Change Order

PROJECT: (Name and address)
Raymond Community Park
Prosper, TX

CHANGE ORDER INFORMATION:
Change Order Number: 04
Date: October 15, 2025

The Scope of Work is modified as shown in the attached DCI PCR 042A dated 22 JUL 25 and
DCI PCR 046 dated 08 SEP 25.

IRRIGATION PLAN - AREA 14

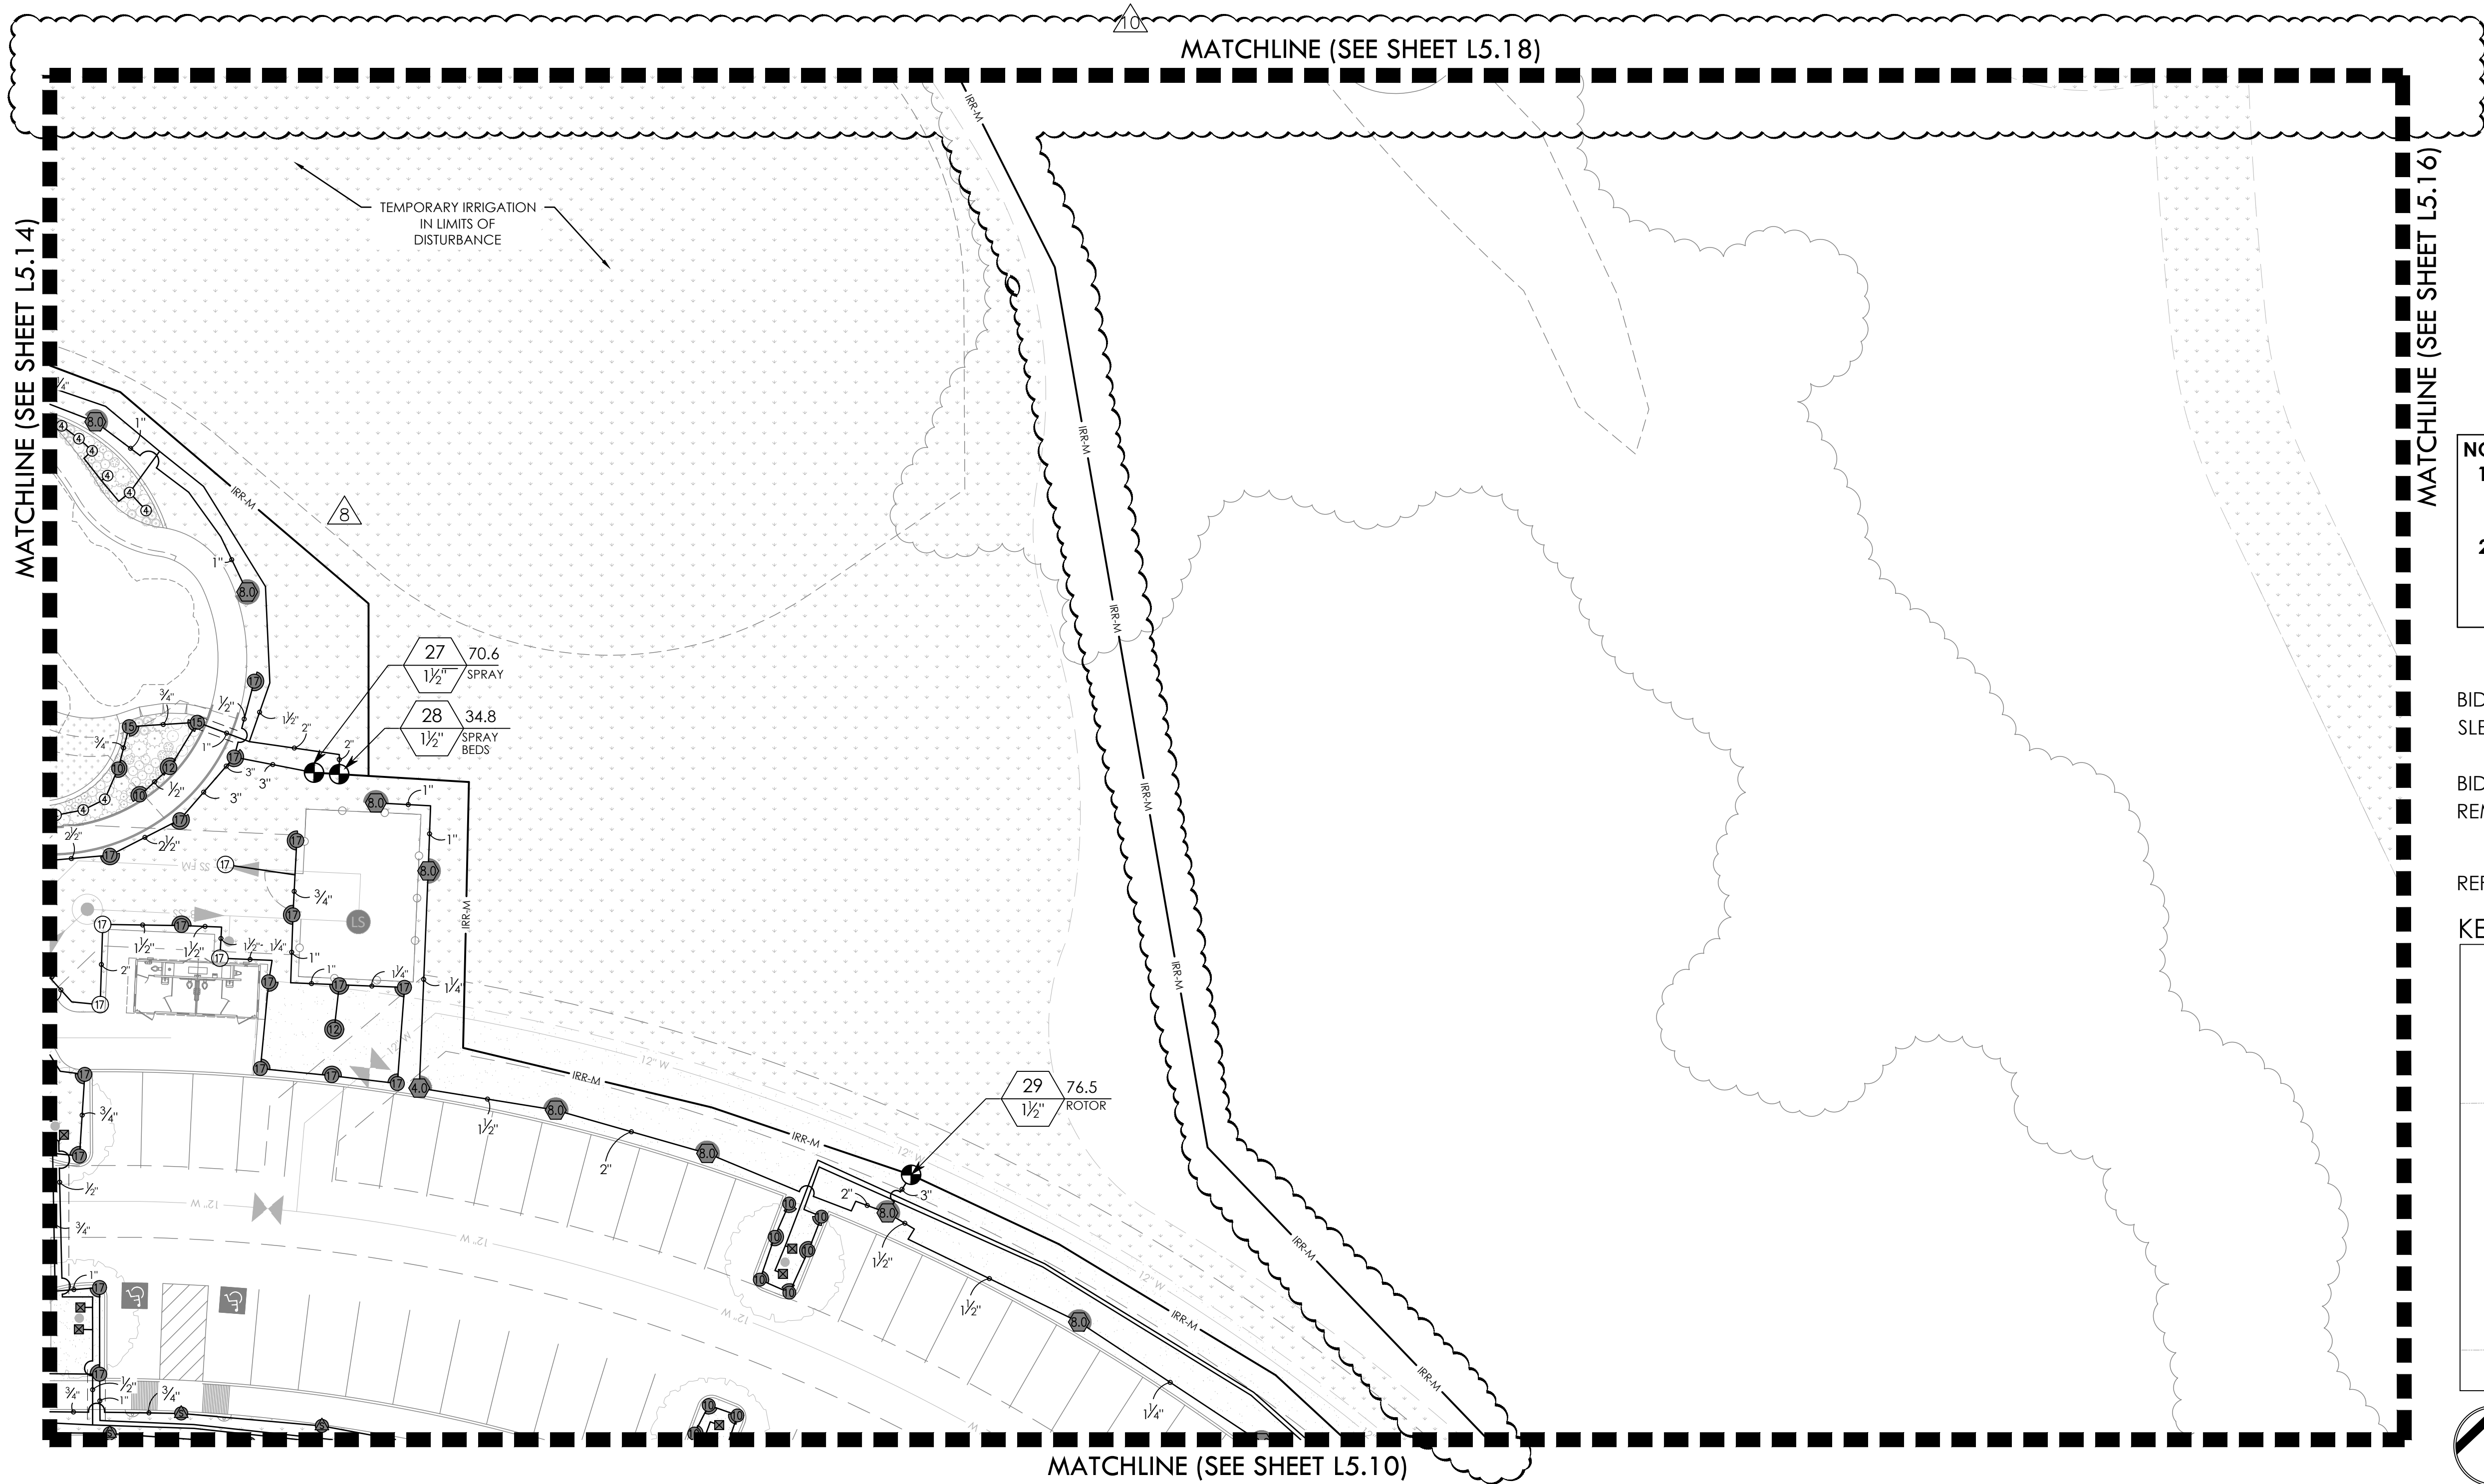
9. L5.12 - Irrigation Plan – Area 12
 - Add irrigation mainline for new north pump location
10. L5.14 – Irrigation Plan – Area 14
 - Add irrigation mainline for new north pump location
11. L5.15 – Irrigation Plan – Area 15
 - Updated viewport area to exclude pump area so that it could be shown on one whole sheet (Sheet L5.18)
 - Add irrigation mainline for new north pump location
12. L5.17 – Irrigation Plan – Area 17
 - Removed mainline that fed old pump location
13. L5.18 – Irrigation Plan – Area 18
 - Updated viewport area to include all pump/well equipment
 - Added pumps, equipment, updated locations and added/updated notes
